SIB 61 01 20

ACCESSORIES DO NOT POWER ON

This Service Information Bulletin (Revision 1) replaces SI B61 01 20 **dated February 2020**.

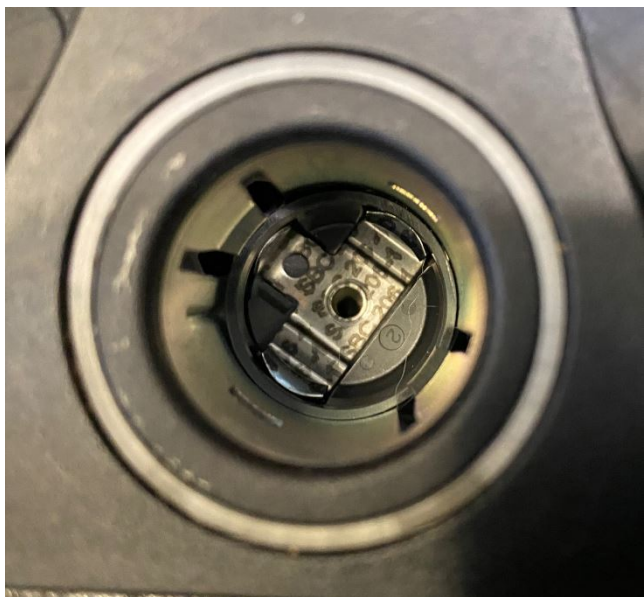
2. Loosen the Torx bolt using a T10 bit driver. DO NOT apply too much downward pressure as this can cause the power socket to come apart underneath.

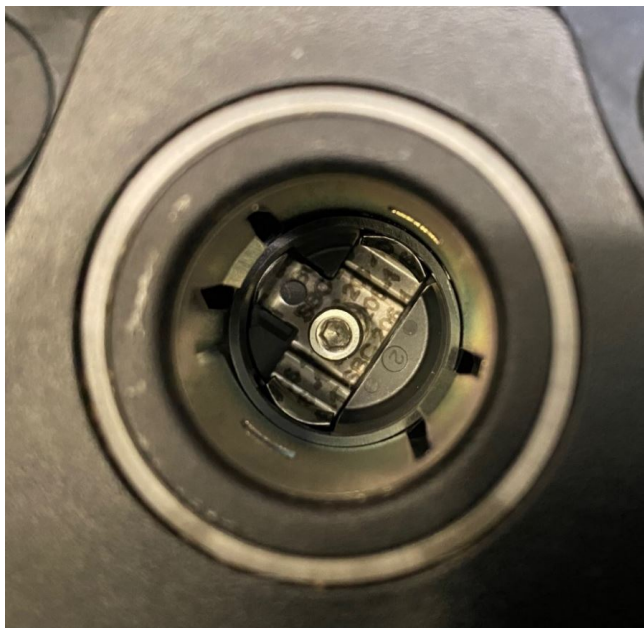
3. Remove the Torx bolt.

4. Insert the replacement bolt and hand tighten (McMASTER-CARR, item number 91292A112).

5. Using Special Tool 0496778, torque the bolt

to 1 NM.
